**SUBDIVISION REVIEW SHEET****CASE NO.:** C8-2019-0057.1A**PC DATE:** Jan. 12, 2021**SUBDIVISION NAME:** Pearson Ranch West Phase One Subdivision**AREA:** 40.544 ac.**LOT(S):** 8**OWNER:** Pearson Ranch, LLC (Brett Ames)**AGENT/APPLICANT:** Brian Grace, P.E. (BGE, Inc.)**ADDRESS OF SUBDIVISION:** 14320 RR 620     **COUNTY:** Williamson**WATERSHED:** Lake Creek**EXISTING ZONING:** GR-MU**PROPOSED LAND USE:** Multifamily, ROW and Parkland

**CITY OF AUSTIN –DEVELOPMENT SERVICES DEPARTMENT  
SUBDIVISION APPLICATION – MASTER COMMENT REPORT**

CASE NUMBER: C8-2019-0057.1A  
 UPDATE: U1  
 CASE MANAGER: Joey de la Garza      PHONE #: 512-974-2664

PROJECT NAME: Pearson Ranch West  
 LOCATION: 14320 N FM 620 RD SB

FINAL PLAT

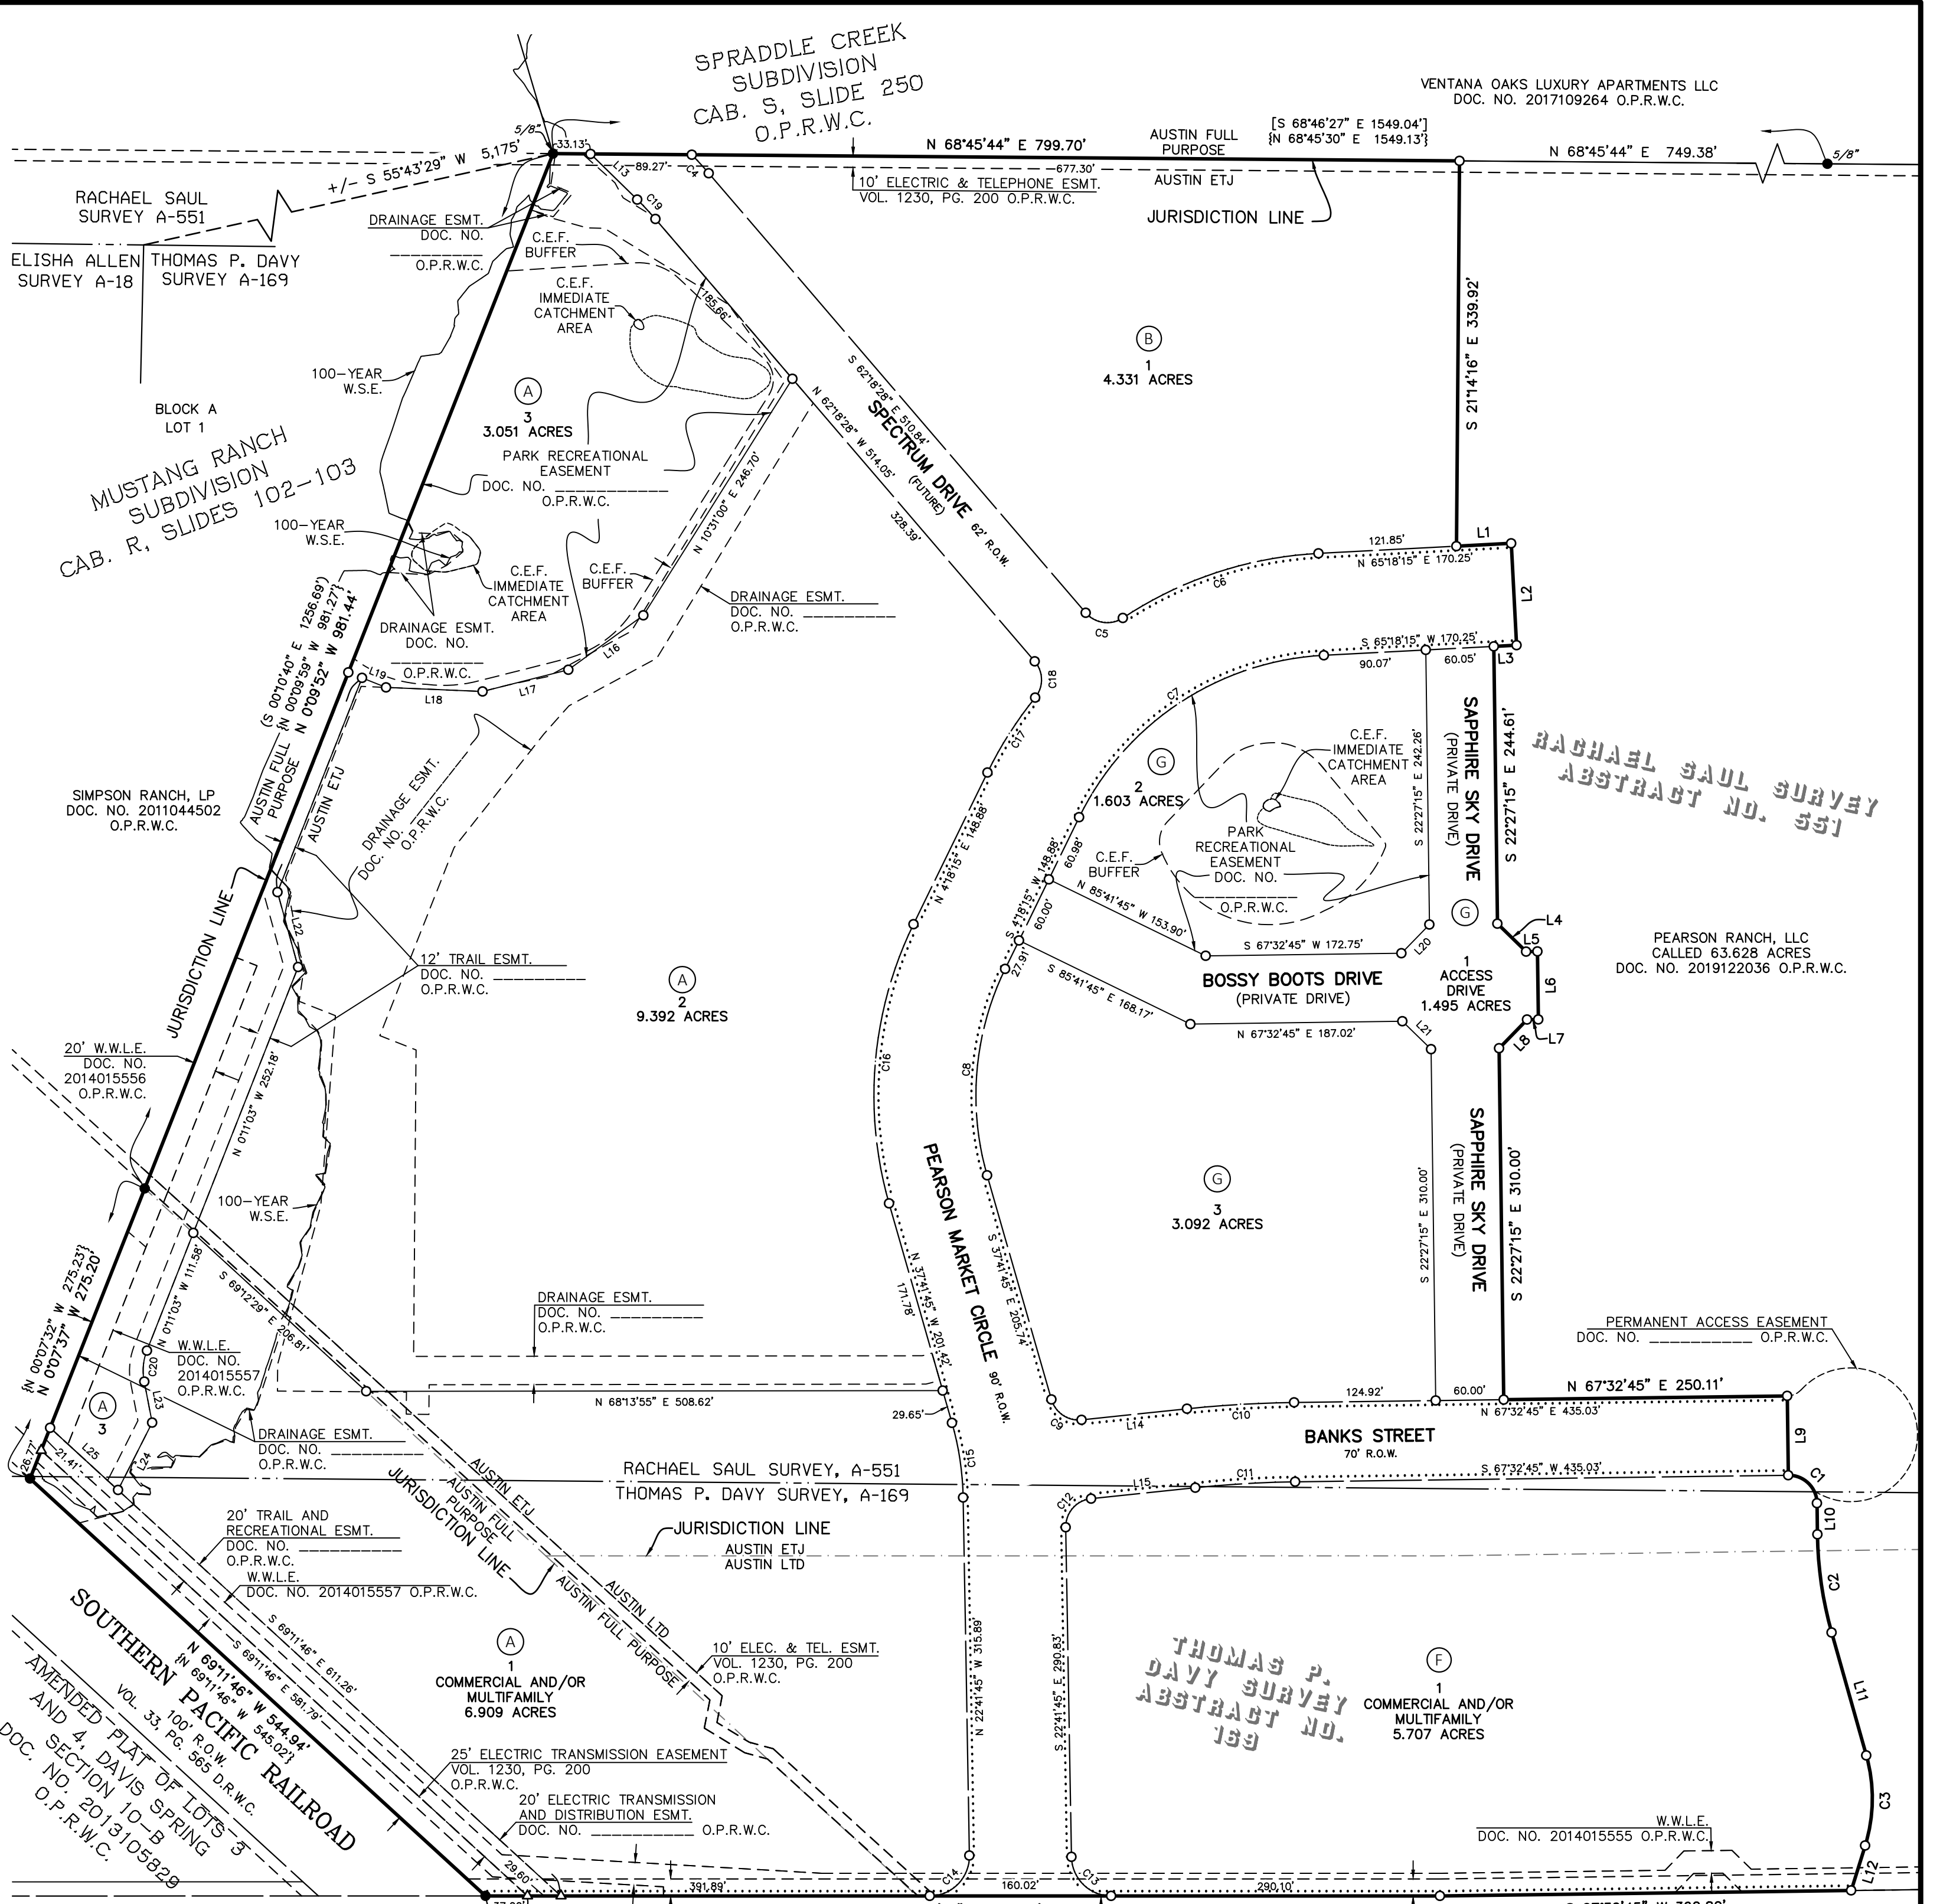
EV 1 Remove the specific reference to the Watershed and Watershed Classification shown in plat note number 16. **[LDC 25-1, Article 4]**

EV 3 Provide the recorded Restrictive Covenant numbers for plat notes 19, 20, and 21.

PR 5: Please remove note #18, #32 is sufficient.

PR 6: Please extend the private park to touch ROW of Spectrum Drive for at least 150 ft, to comply with our PDOP, specified in [Section 25-1-602](#)

- a) **Revise plat note 20 to read: "A RESTRICTIVE COVENANT REGARDING ALLOCATION OF IMPERVIOUS COVER HAS BEEN RECORDED IN DOCUMENT NO. \_\_\_\_\_ OF THE OFFICIAL RECORDS OF WILLIAMSON COUNTY, TEXAS FOR LOT 1, BLOCK B."**
- b) **Revise plat note 21 to read: "A RESTRICTIVE COVENANT REGARDING ALLOCATION OF IMPERVIOUS COVER HAS BEEN RECORDED IN DOCUMENT NO. \_\_\_\_\_ OF THE OFFICIAL RECORDS OF WILLIAMSON COUNTY, TEXAS FOR LOTS 1-3, BLOCK G."**

**Please remove any reference to the un-platted land in these plat notes along with the reference to the approved preliminary plan as they are not appropriate and do not belong on this plat.**
